CITY OF FRANKLIN

REPORT TO THE PLAN COMMISSION

**Planned Development District No. 37 Minor Amendment, Site Plan,
and Certified Survey Maps**

RE: Ballpark Commons Planned Development District Minor Amendments and Site Plan
Pertaining to Buildings B1, B2, B3, and B4 – Staff Comments

**BUILDING 'B1' -
EXTERIOR ELEVATIONS
(BLDG. 'B4' SIM)**

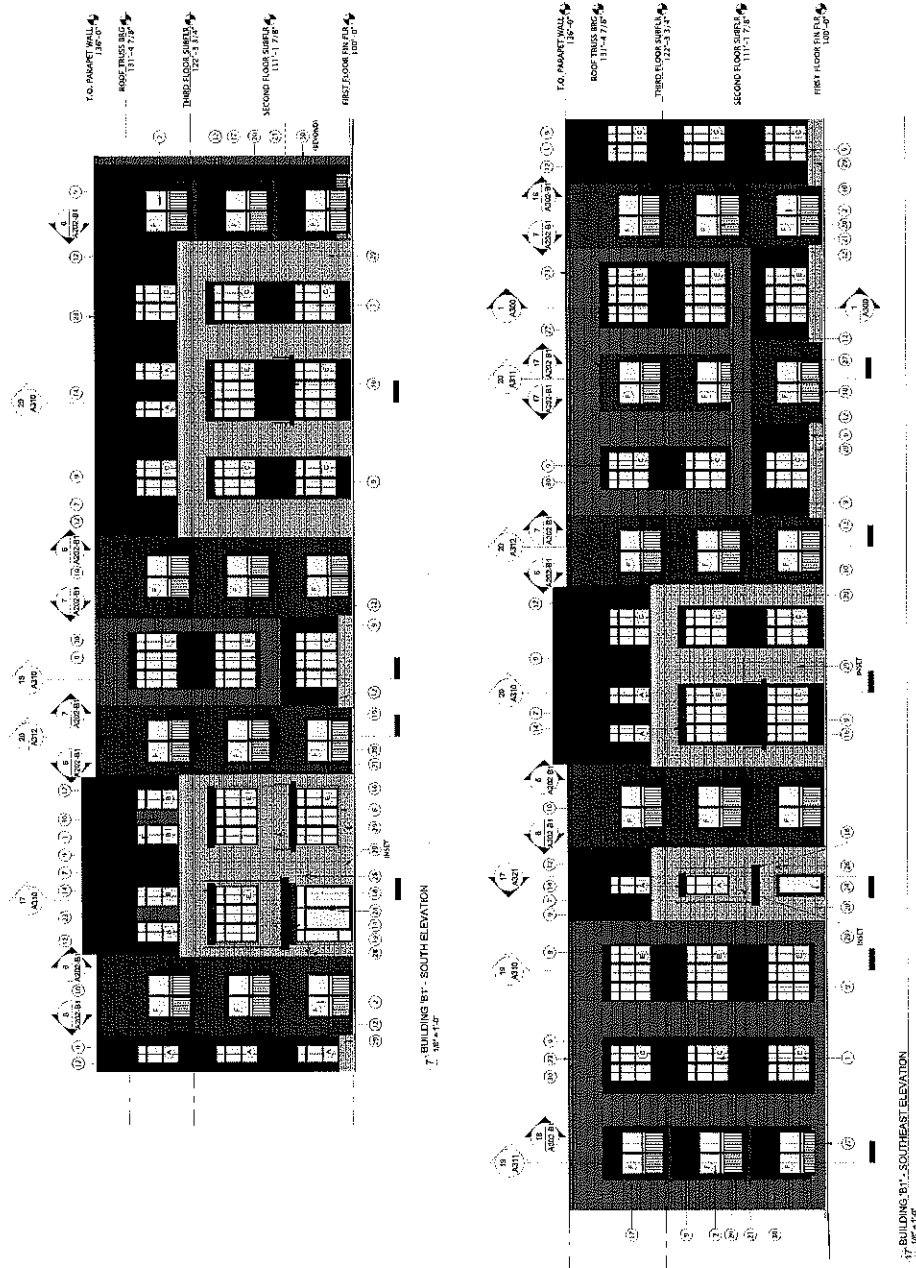
- Both the Unified Development Ordinance and the PDD No. 37 Design Standards require that building design shall not be repeated on four or more buildings.
 - While the applicant has revised the Architecture Plan to provide an additional color of brick and of composite lap siding on the four buildings, and has varied the placement of these materials, staff does not agree that this is enough variation. Staff would also note that it is possible that up to six essentially the same apartment buildings will be constructed.
 - Similarly, staff is concerned that the buildings do not provide enough articulation.
 - Staff recommends that at least one of the buildings be revised to include addition of a new short wing, that the ends of the building be reduced from 3 stories to 2 stories, and that larger entrances that are more prominent be added to the building.

SHEET 9 OF 28

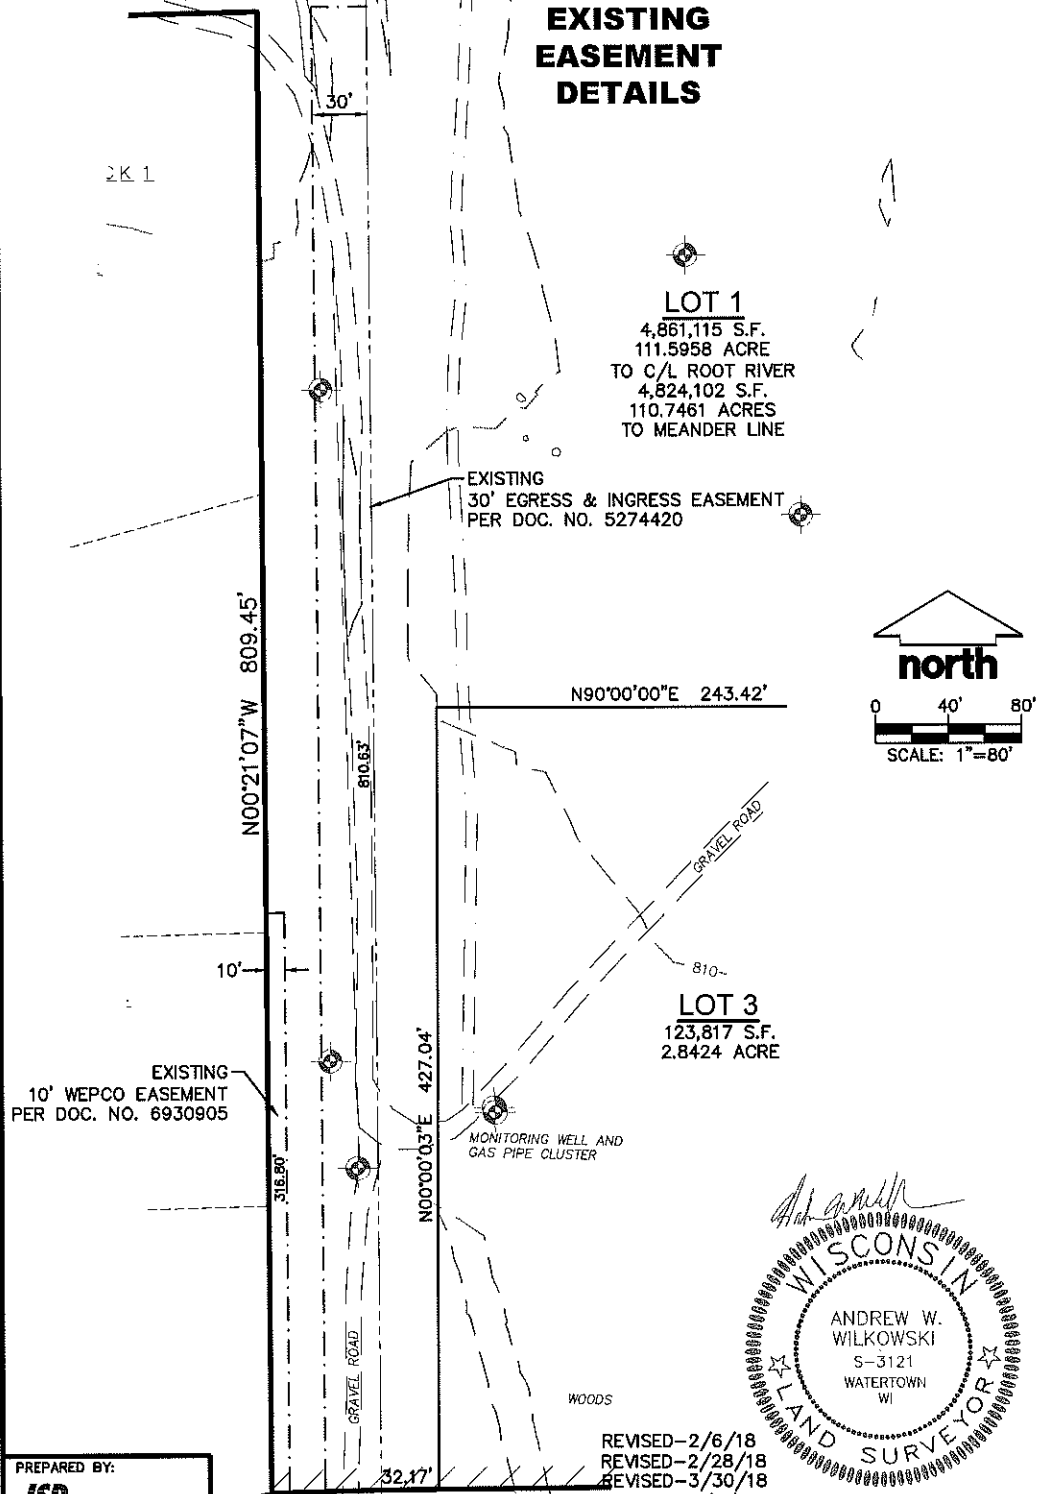
12. Please revise L-12 in the Line Table on Sheet 9. It should be northwest, not northeast.
 - *The line direction is correct, as shown.*
13. Please add a statement to Sheet 1 of the CSM indicating if the land is served by sanitary sewer and water.

36. On Sheet 9, staff recommends replacing the "Wetland" label on Lot 2 to "Conservation Easement."
- *Complete.*
37. On Sheet 9, the CSM illustrates the wetland area as well a proposed storm sewer easement. Is there sufficient room to locate the proposed retaining wall between the easement area and protected wetland?
- *Yes, however, this is one of the previously mentioned easements that we would suggest be removed from the CSM until such time as the engineering and permitting is completed.*
